SERVICE BULLETIN

MANDATORY No. 05.92

SUBJECT: TIME LIMITS
 Main Rotor Blade Root Skin and Reinforcement Strip Bonding Check

FIGURE 1

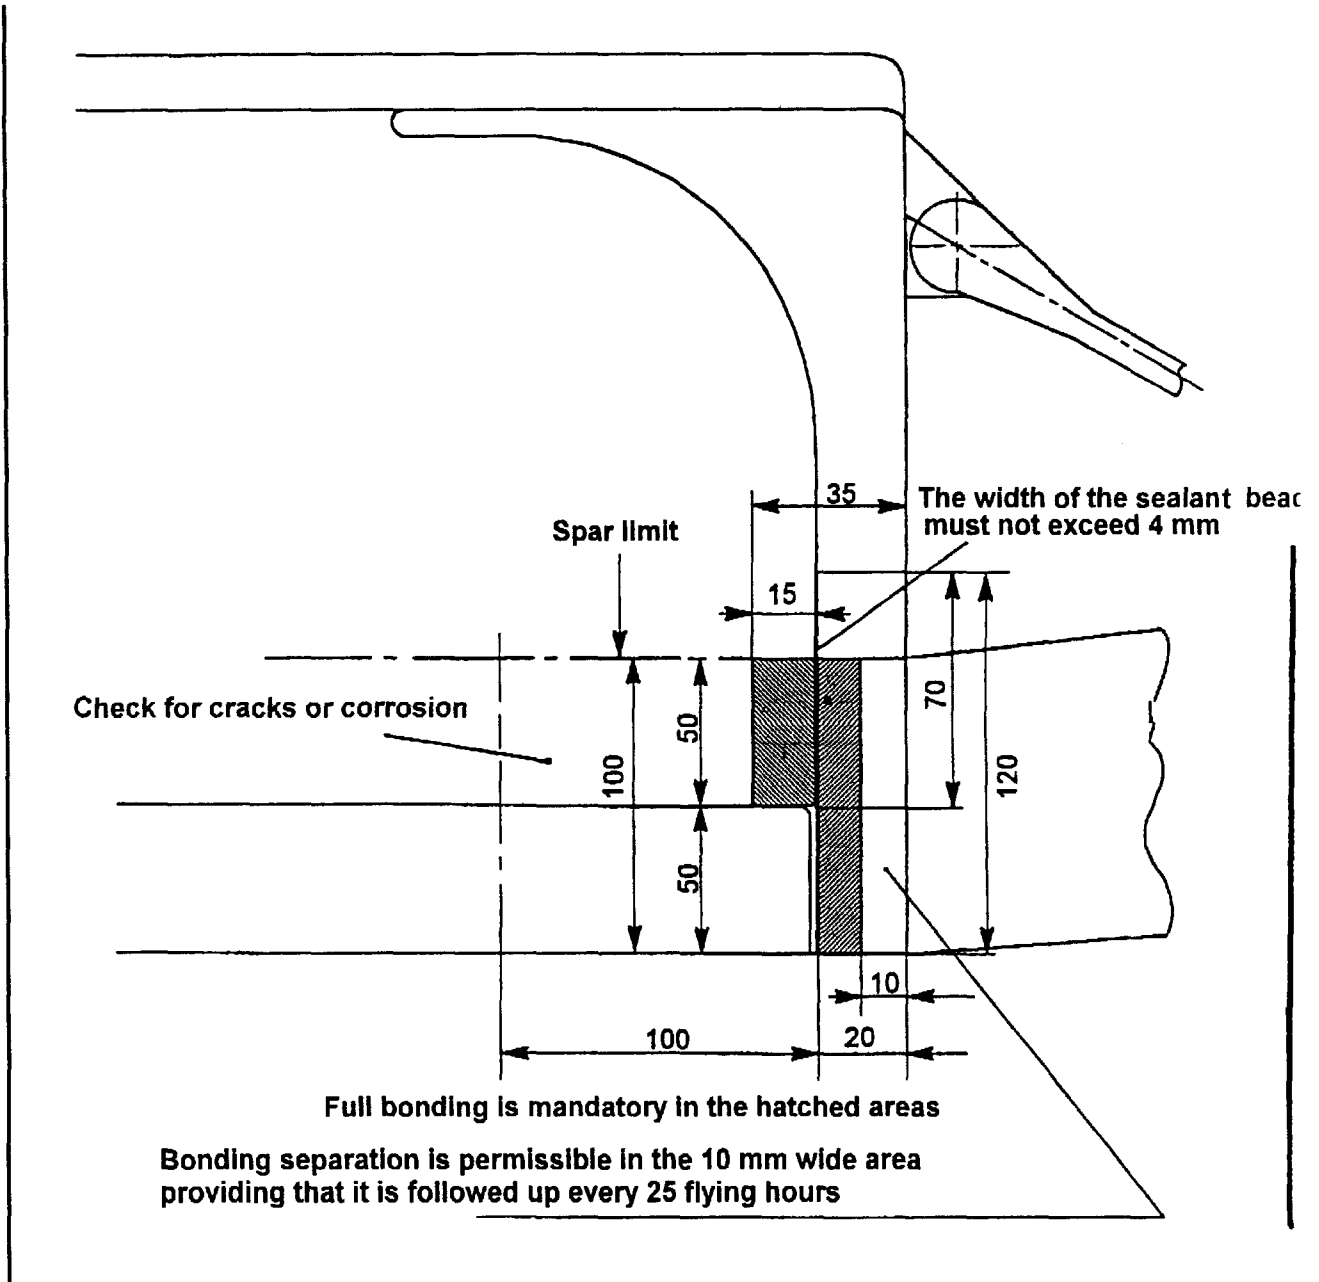
- 1) increases the width of the seal from 2 mm to 4 mm, in order to take into account creeping of the resin, that is difficult to remove.
- 2) determines a zone of acceptable bonding separation in the blade root reinforcement strip area; this zone is to be followed up at reduced checking interval: every 25 flying hours.

- Hatched area of skin on spar, 15 x 50 mm, aft of the stainless steel protection (upper surface and lower surface) see FIGURE 1

Inspect the sealant bead along the reinforcement strip: if the width of the sealant bead exceeds 4 mm remove it over a length of 70 mm from the leading edge using a Plexiglas scraper only. R
R
R

- Reinforcement strip area (upper surface and lower surface) (see FIGURE 1) R

- Check that there is no bonding separation in the reinforcement strip area (100 x 20 mm), using tapping method. R

- If any bonding separation is detected in the hatched area, the blade must be withdrawn from service. R

- Bonding separation in the non-hatched area (10 mm) is permissible and must be checked using tapping method every 25 flying hours in order to monitor possible propagation. As soon as a bonding separation reaches the hatched area, the blade must be removed. R
R
R

During subsequent inspections (every 100 flying hours or 6 months: the first limit reached is applicable, or every 25 flying hours if there is a bonding separation in the 10 mm wide non-hatched area on the strip (FIG. 1)), the 4 mm-wide sealant bead is no longer to be removed unless crazings appear as described above. R
R

- Check that there is no bonding separation in this area, using tapping method.
- If any bonding separation is detected in this area, the blade must be withdrawn from service.
